APPLICATION FOR SUBMITTAL OF POST-APPROVAL DOCUMENT

2. PROJECT INFORMATION:			
School District/Owner: <u>Bakersfield City School District</u>		DSA File Number: <u>15 6</u>	
Project Name/School: <u>Dr. Martin Luther King Jr. Elementary School</u>		DSA Application Number <u>03 122605</u>

ADDENDUM NO. 2
PROJECT MANUAL
MLK ELEMENTARY SCHOOL
WELLNESS CENTER
BAKERSFIELD CITY SCHOOL DISTRICT

Project No.: 5527
DSA File No. 15-6
DSA App No. 03-122605
December 19, 2024

Sheet No.: **A1.02**

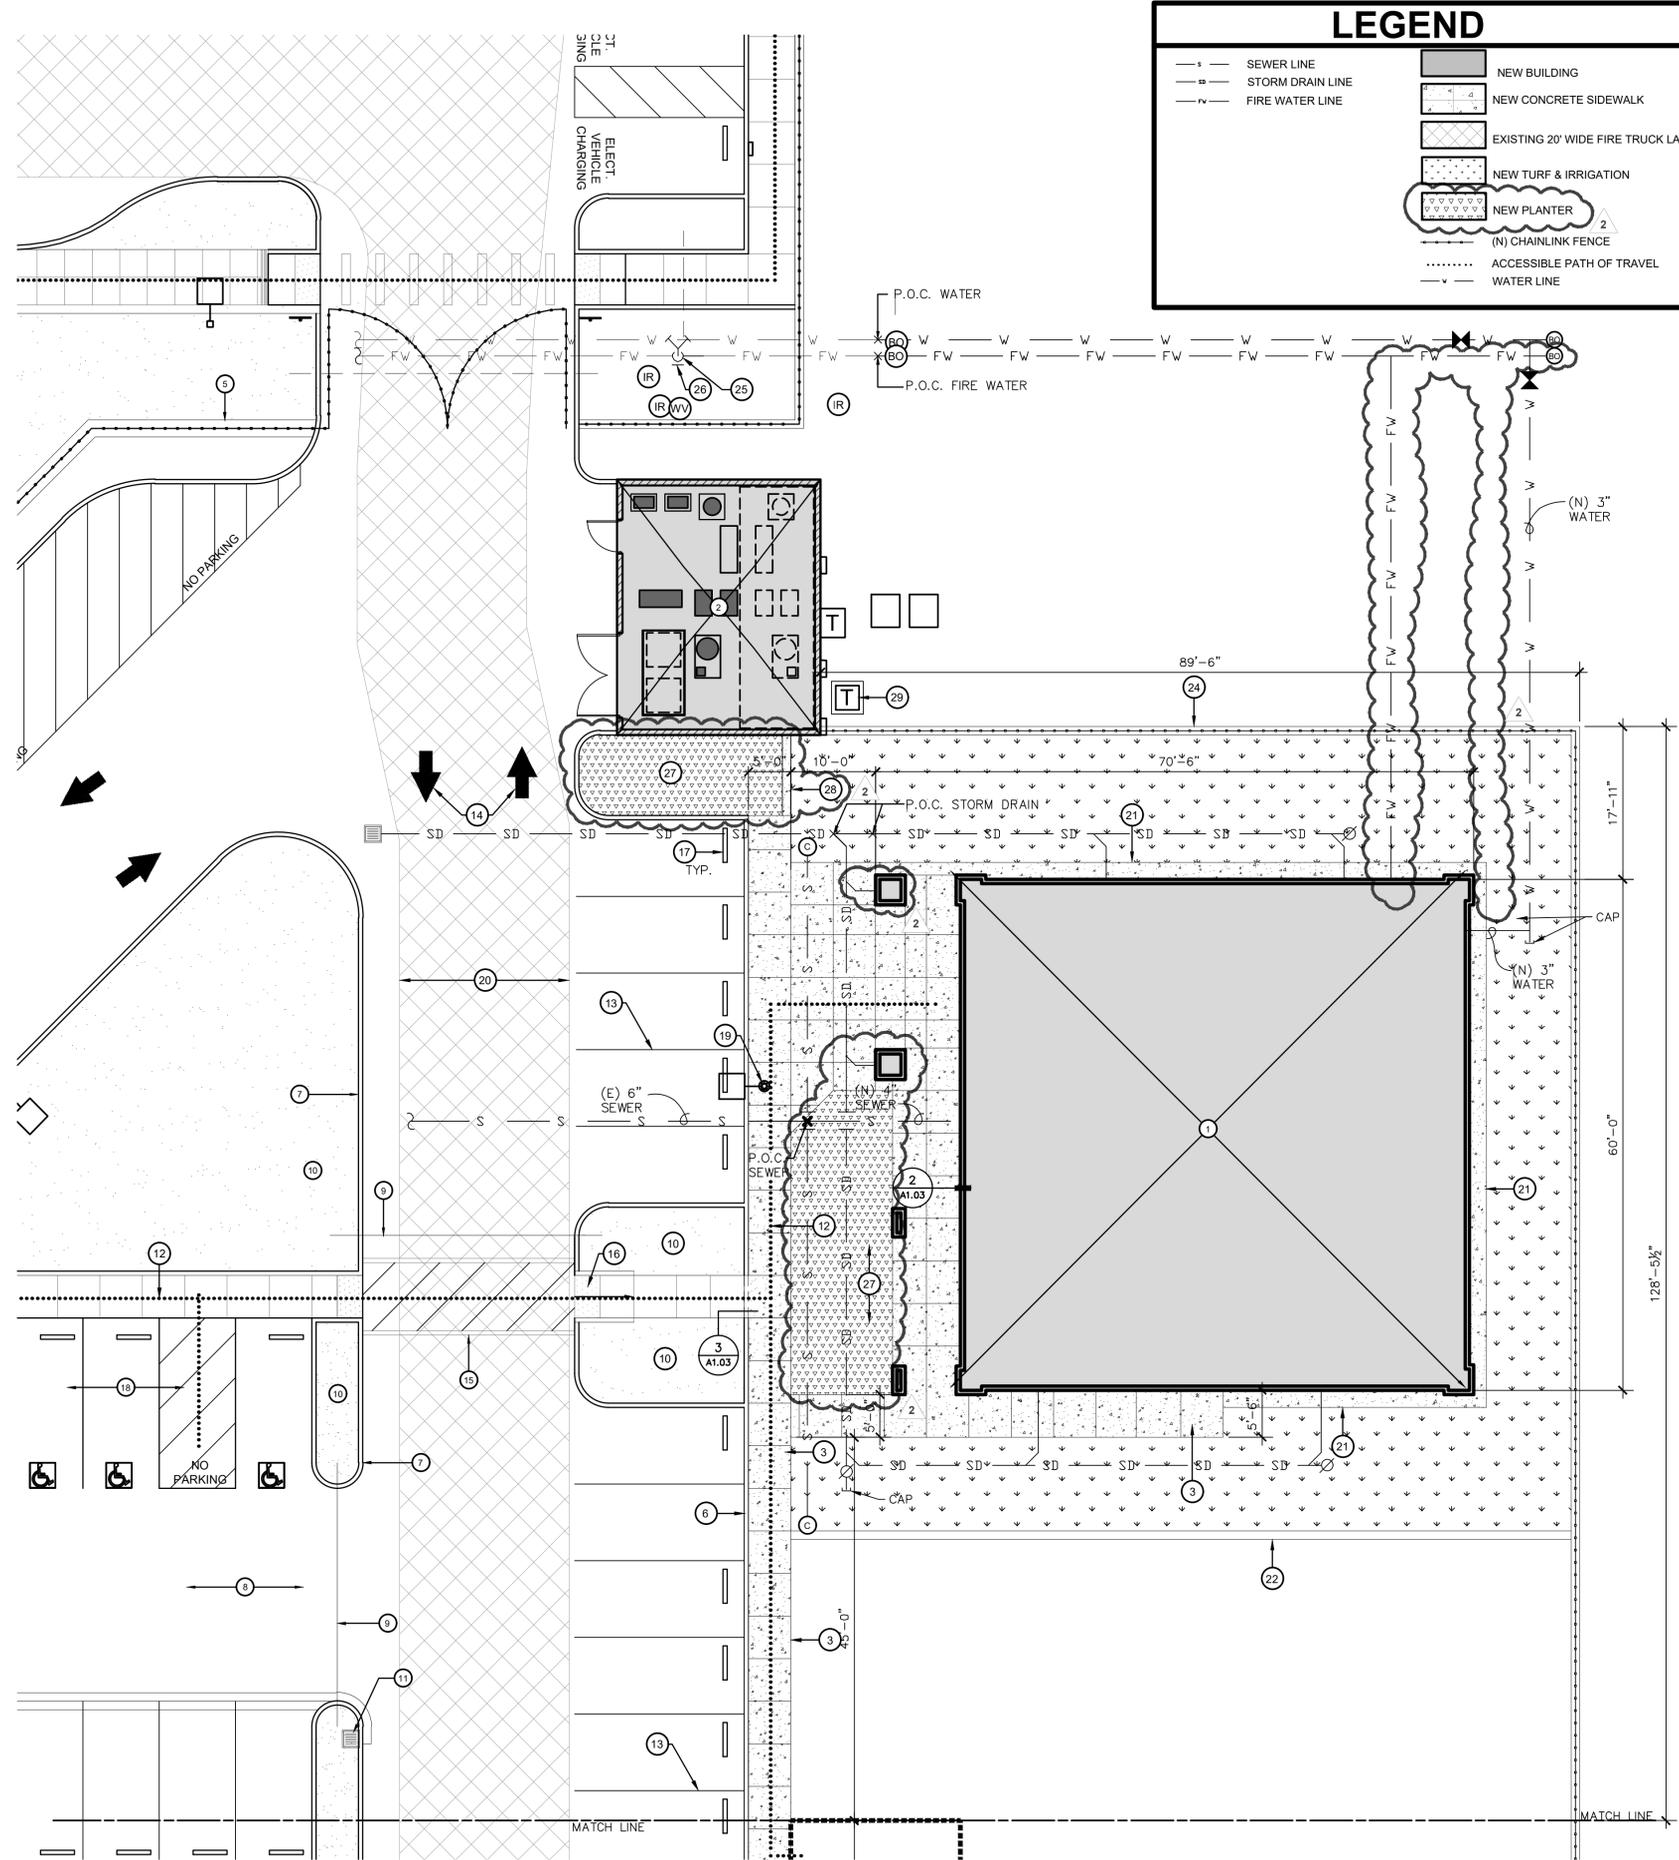
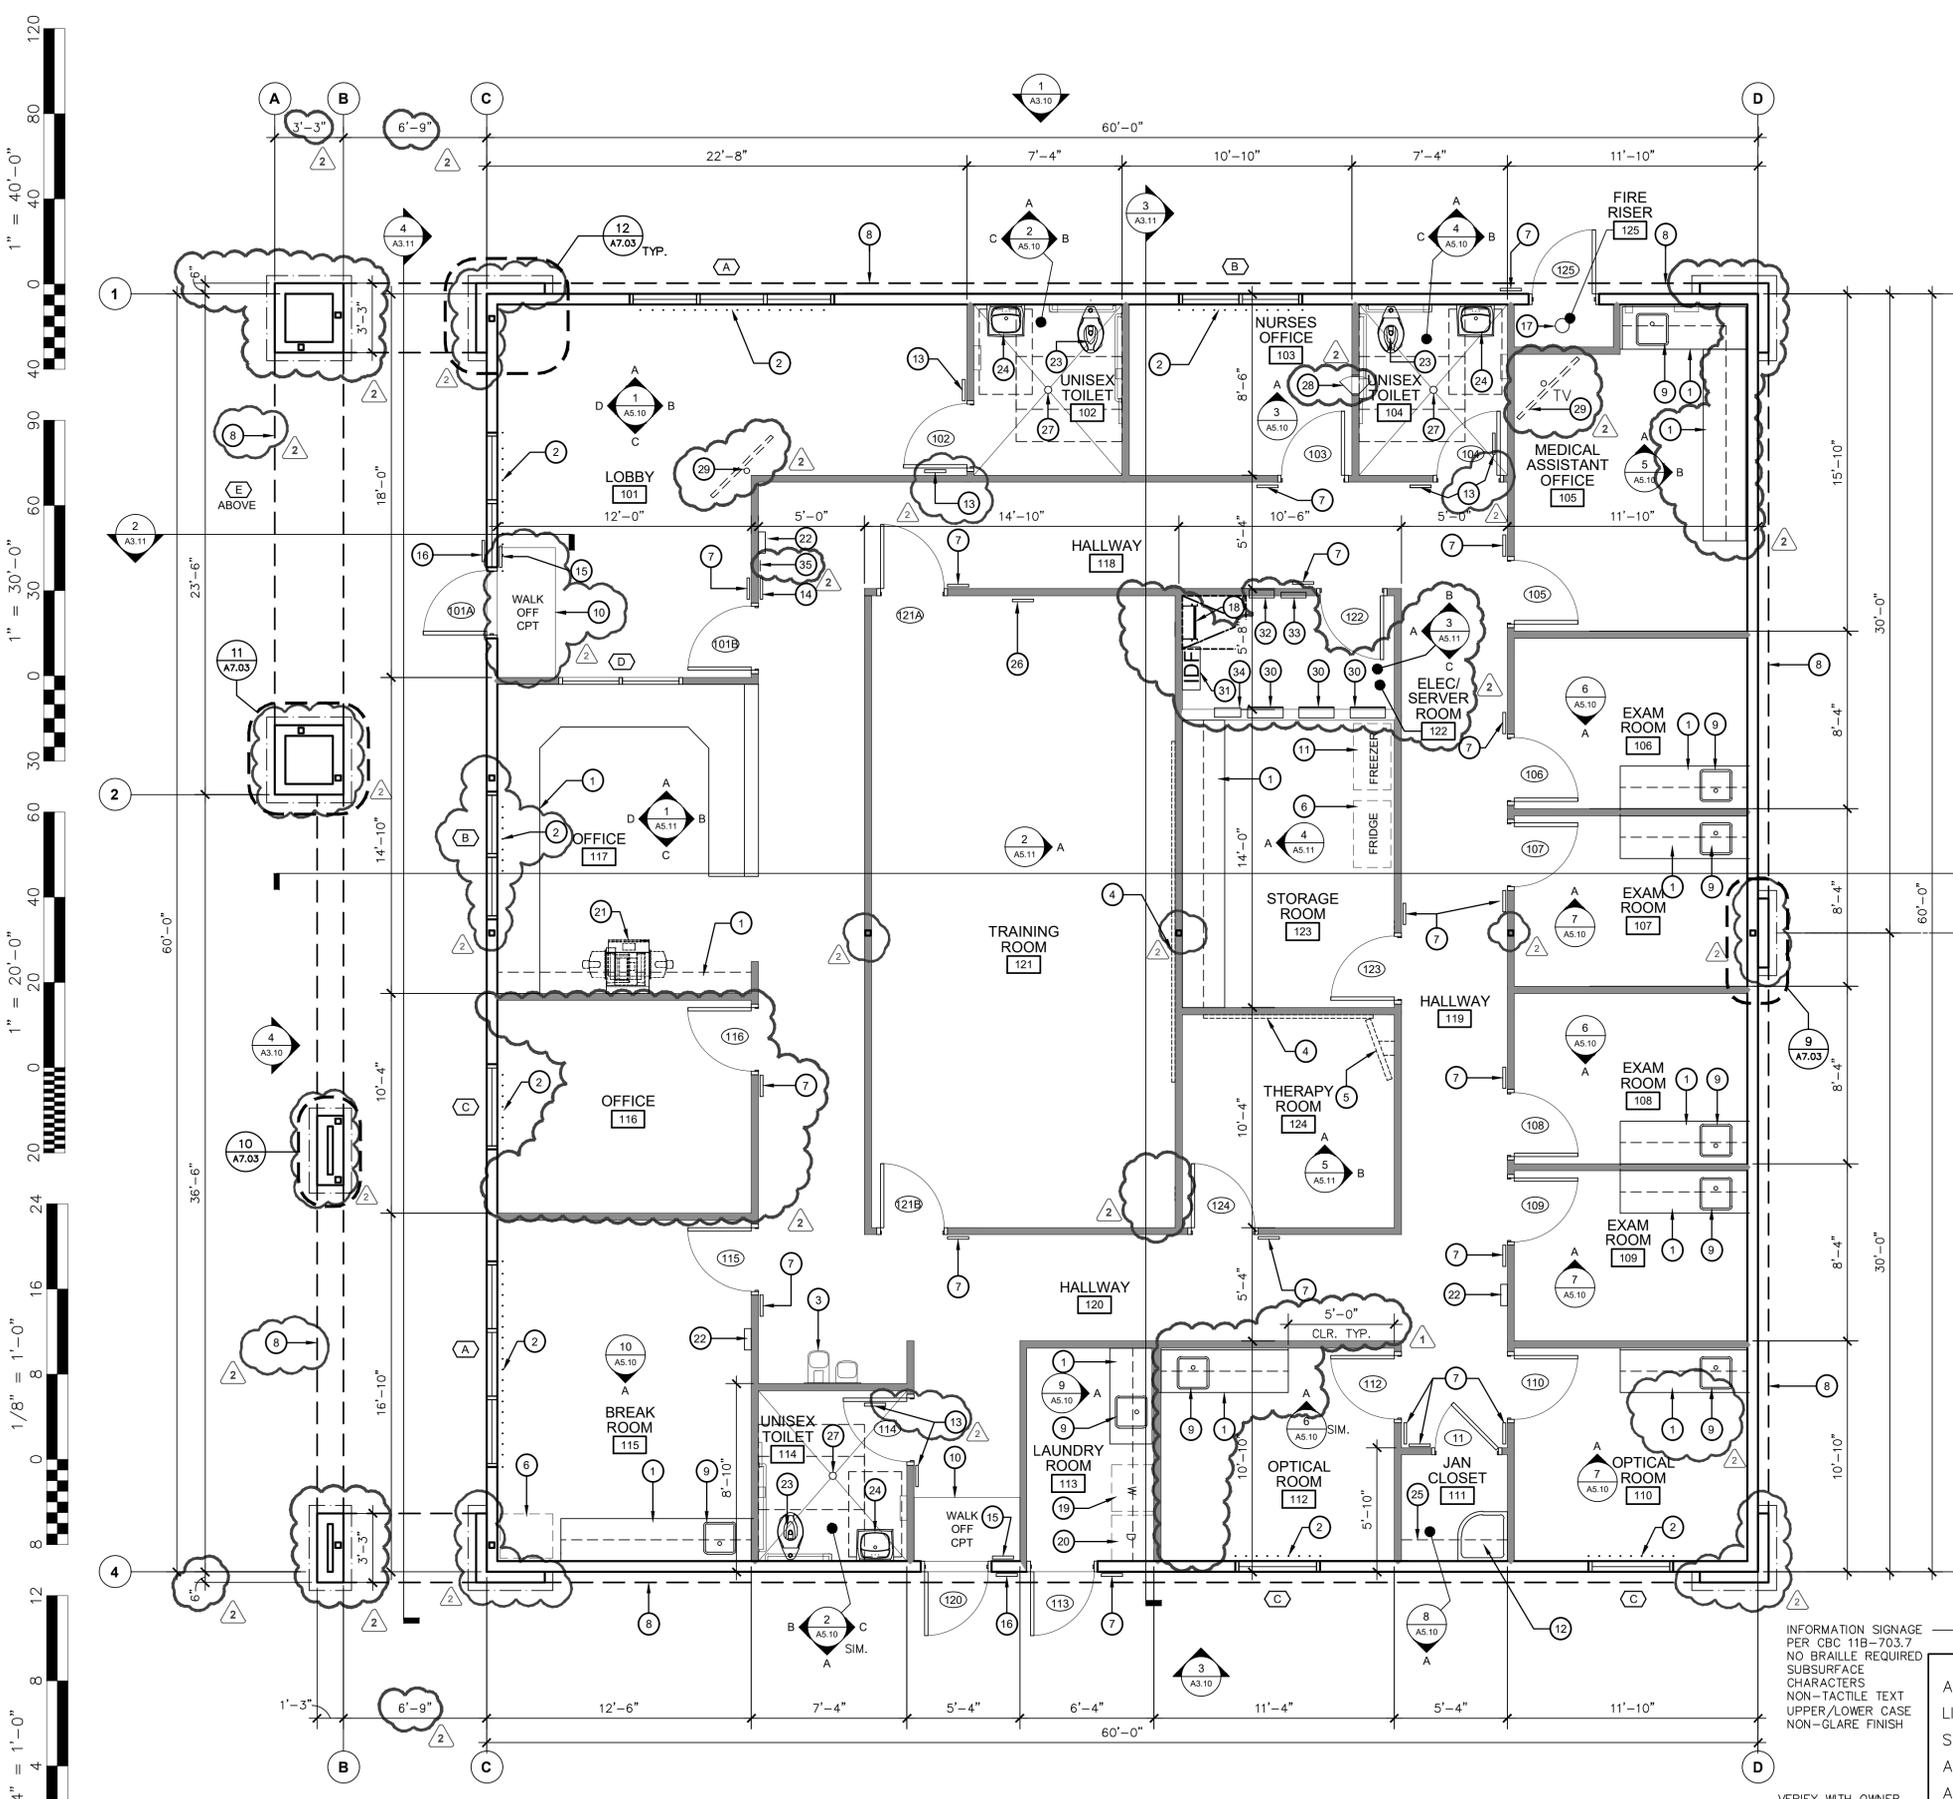
1. Locations for the fire water line has been modified.
2. Storm drain lines have been added on the West side of the building.
3. Keynote 27 has been added.
4. Planter symbol has been added to the legend.
5. Turf areas west of the new building have been replaced with planters. See keynote 27.

Sheet No.: **A3.10**

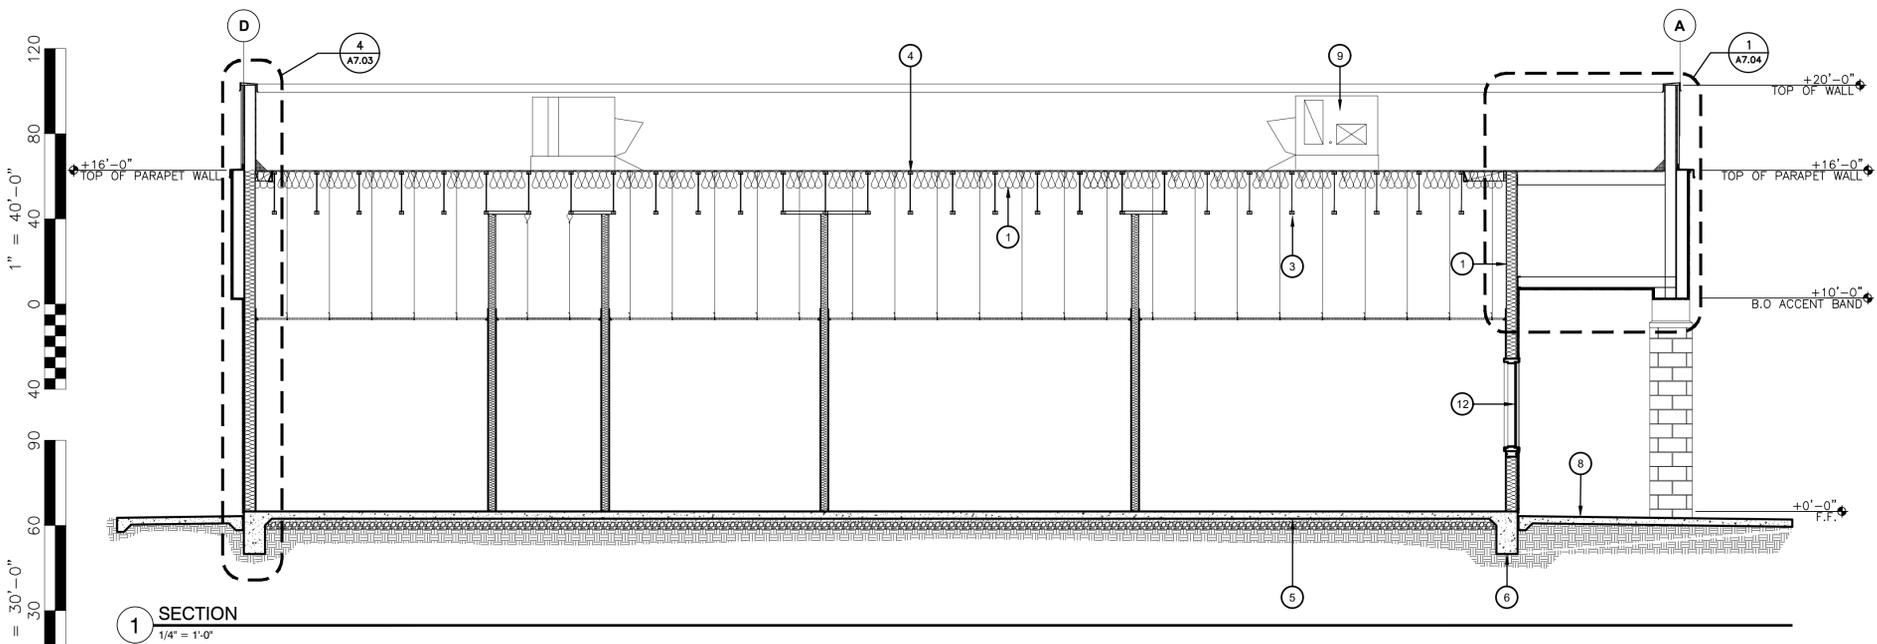
2-12 DRAWINGS, SHEET A3.10 – EXTERIOR ELEVATIONS: Note the following changes (See A3.10 addendum 2 drawing):
